Aberdeen Apartments

Re: Aberdeen Apartments Letter of September 30, 2011 request for alternative loading accommodations

SUBJECT: 437 West Gorham Street

RE: Approval of a request to rezone 434-454 W. Johnson Street from R6 (General Residence District) and C2 (General Commercial District) to Planned Unit Development-General Development Plan-Specific Implementation Plan (PUD-GDP-SIP) to allow demolition of 5 existing buildings and construction of a ten-story, 194-room hotel with approximately 3,300 square feet of first floor retail space (Raymond Management Co.)

1" = 30'-0"
SITE PLAN

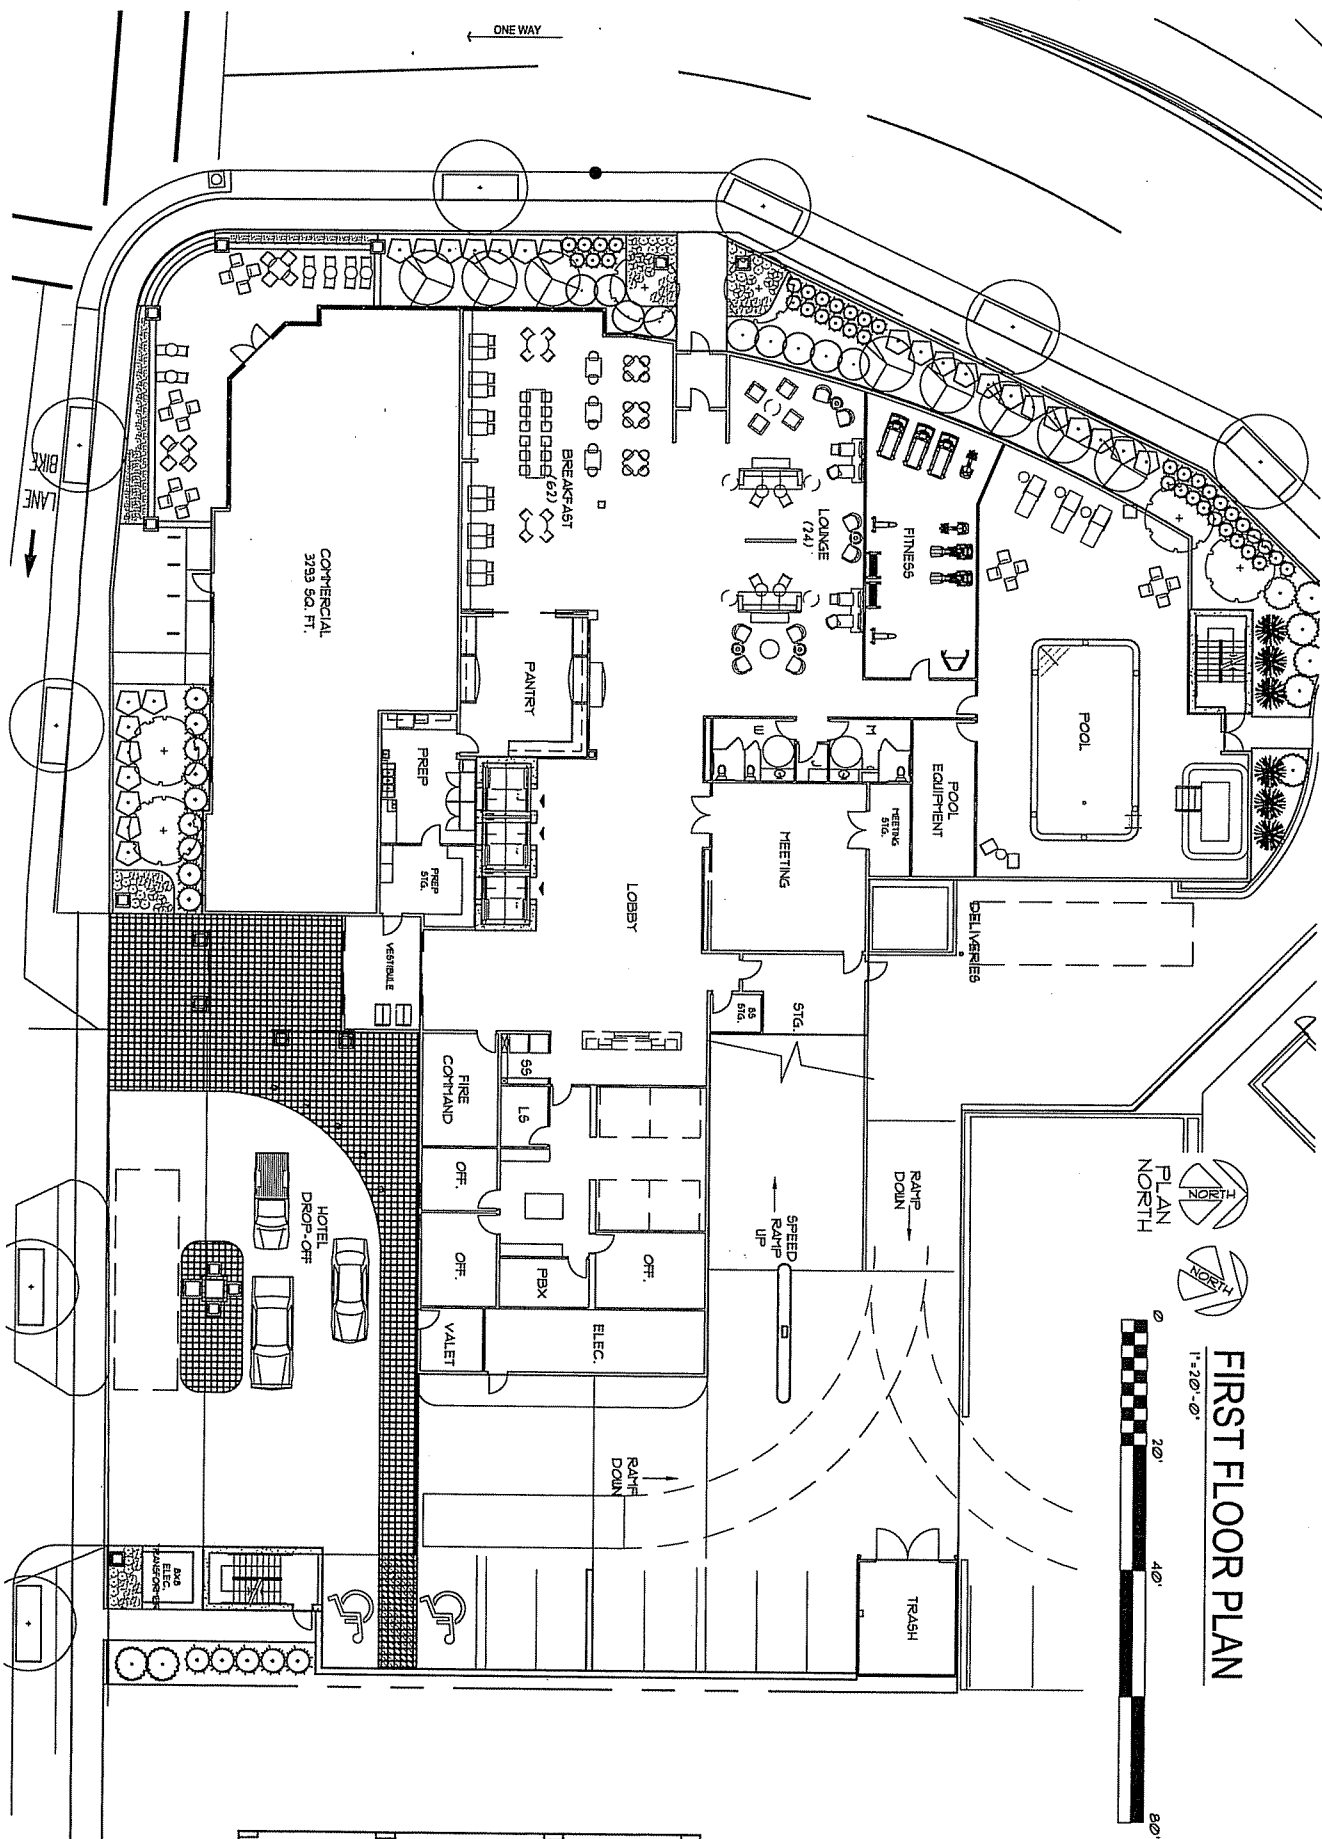
41. That a detailed site plan showing the entire private through-block connection that will extend between the subject site and adjacent Aberdeen Apartment (Dishaw) property from W. Gorham to W. Johnson streets be included in the final plan set for this project. The site plan exhibit should reference the recorded 2003 private driveway cross easement (Document No. 3770757) between the two properties.
